City of Carlisle, Iowa
Planning and Zoning Commission
Regular Meeting
May 17, 2021
7:00 P.M.

RE: **Carlisle Commons – Public Improvements**

RE: **Carlisle Commons – Preliminary Plat & Site Plan**

Thank you for submitting your project for review. The City is committed to assisting you with the completion of this project. FOX Engineering and the City Staff have completed the second review for the Carlisle Commons Site Plan dated May 10, 2021 and have the following comments:

SHEET NUMBER:
C1.1

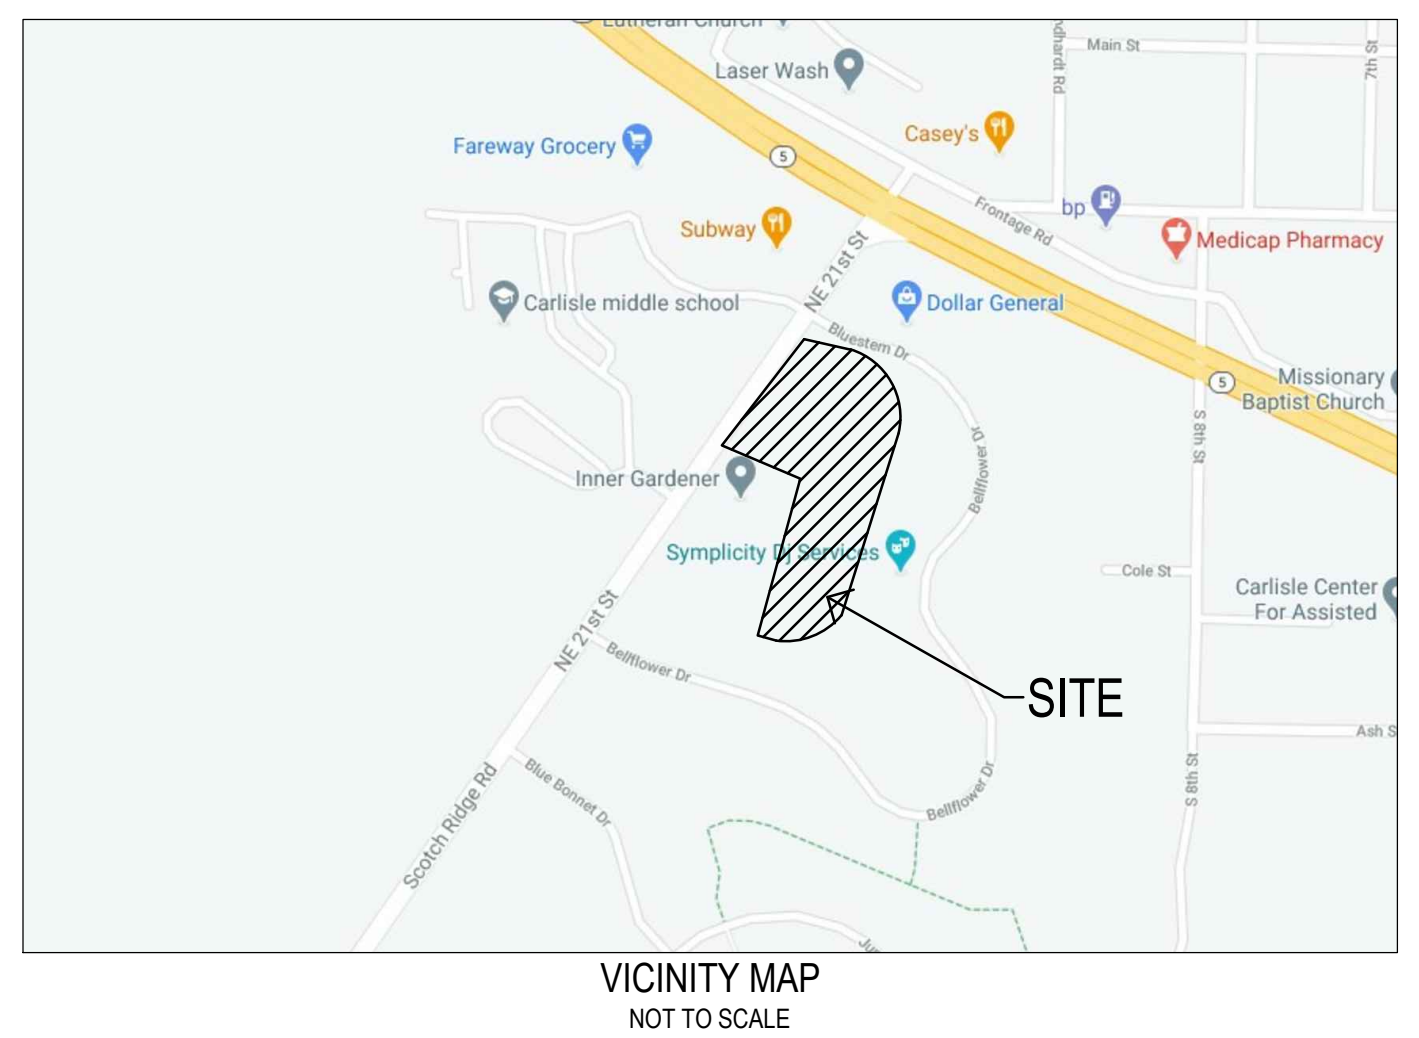
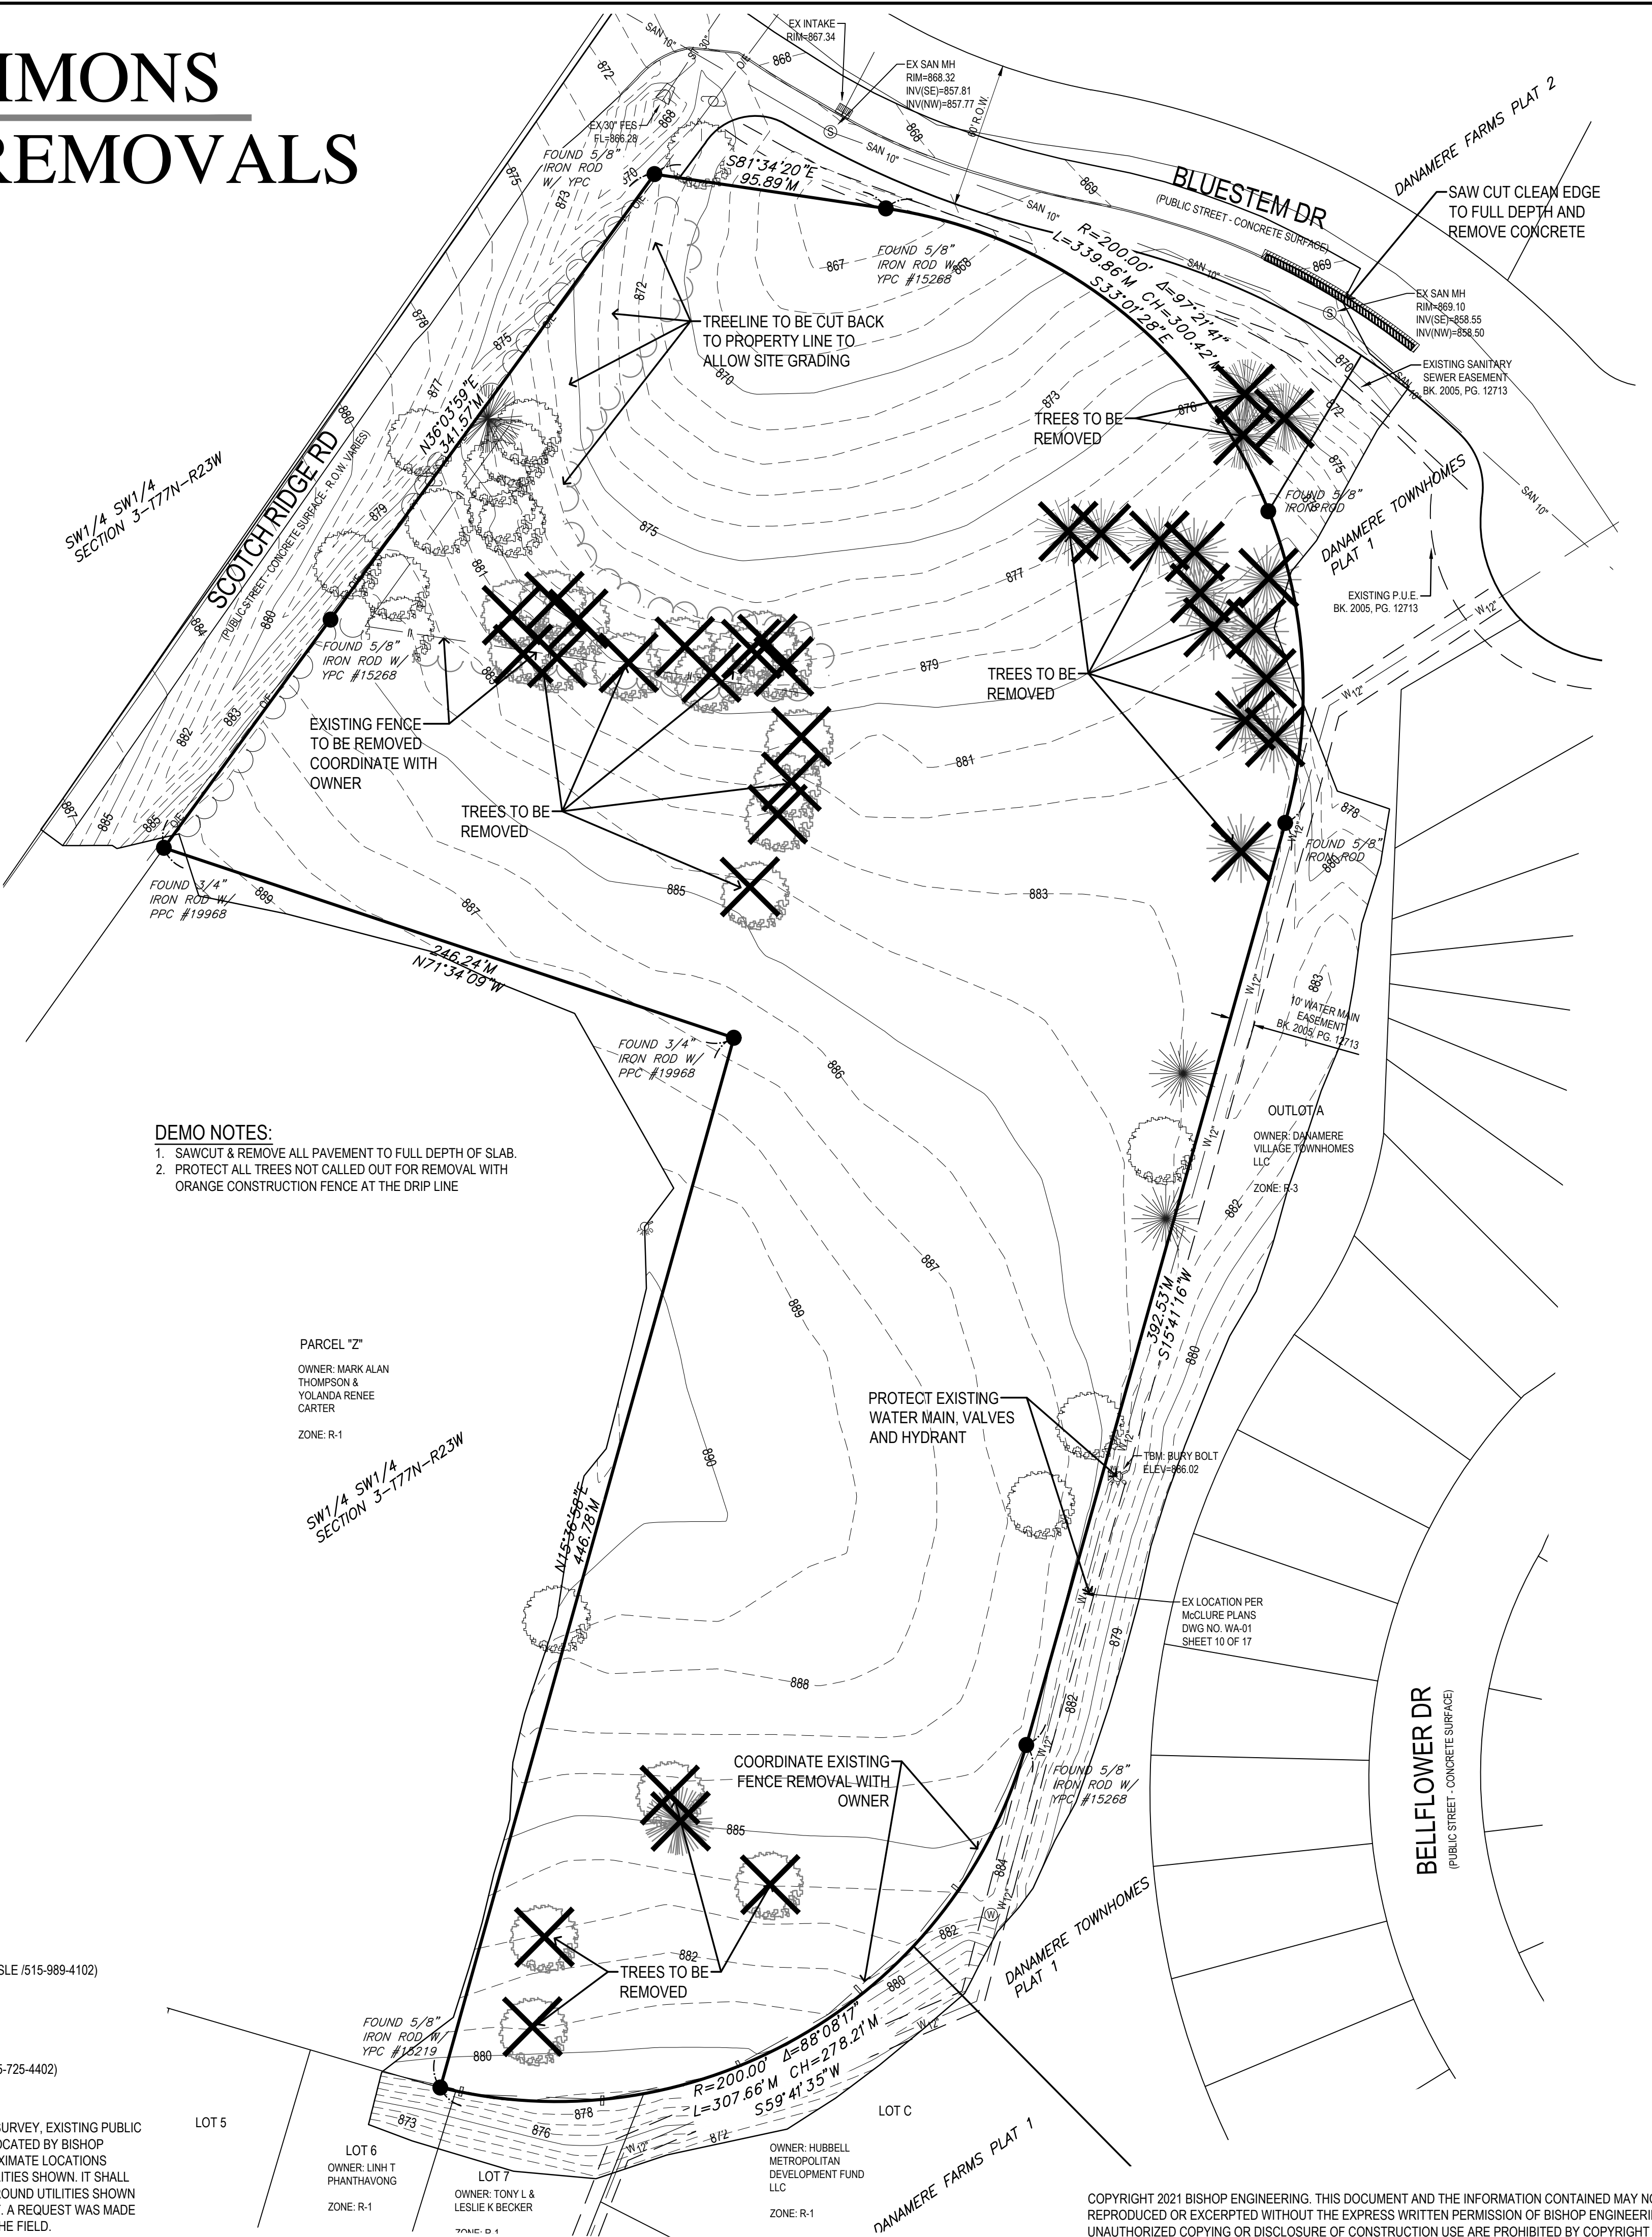
Sheet C1.1 – Site Survey / Removals:

11. Please include City contact information for water/sewer utilities.

REFERENCE NUMBER:	
DRAWN BY:	BK
CHECKED BY:	DB
REVISION DATE:	04/20/2021 CITY#1 05/10/2021 CITY#2 05/14/2021 CITY#3
PROJECT NUMBER:	210080
SHEET NUMBER:	C3.1

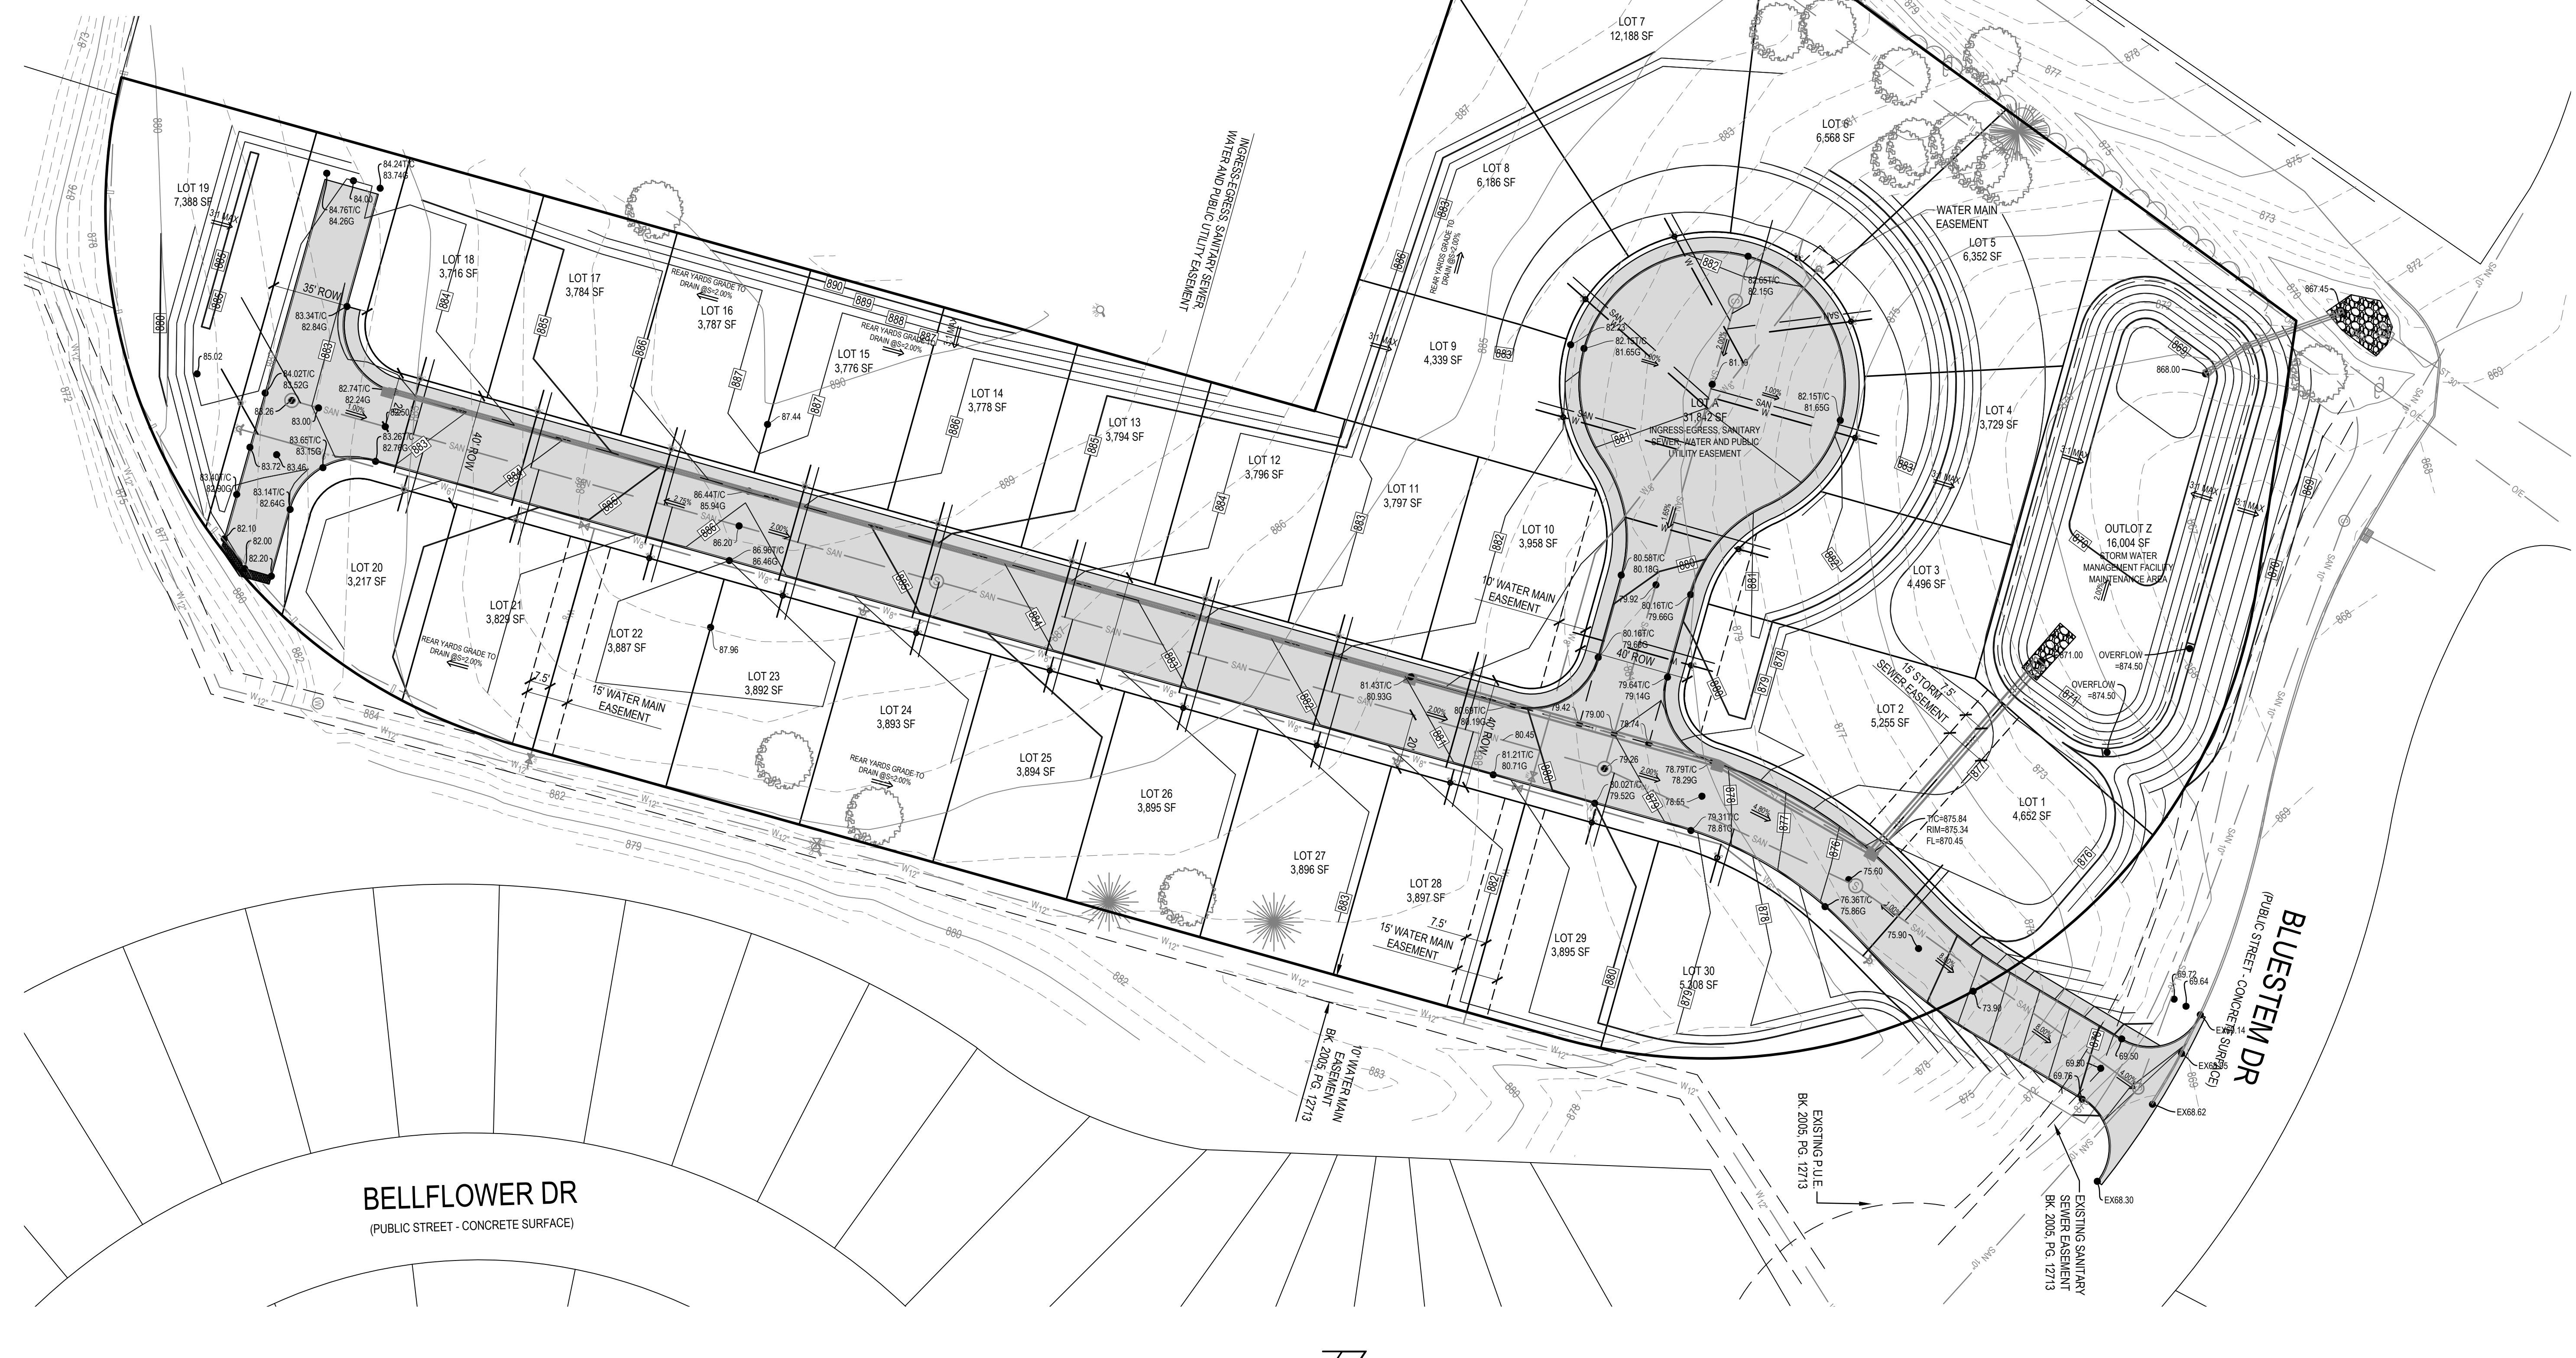
Sheet C3.1 – Grading Plan:

12. Please provide additional details on the plans for the sidewalk ADA ramp across Bluestem Drive.
13. Please review the grading in the rear of Lots 10-18. It appears that a swale and flowage easement may be necessary to convey storm water runoff across multiple lots. Please review and revise the grading plan and/or easement layout accordingly.
14. Please show erosion control at the storm sewer outfalls on this sheet.
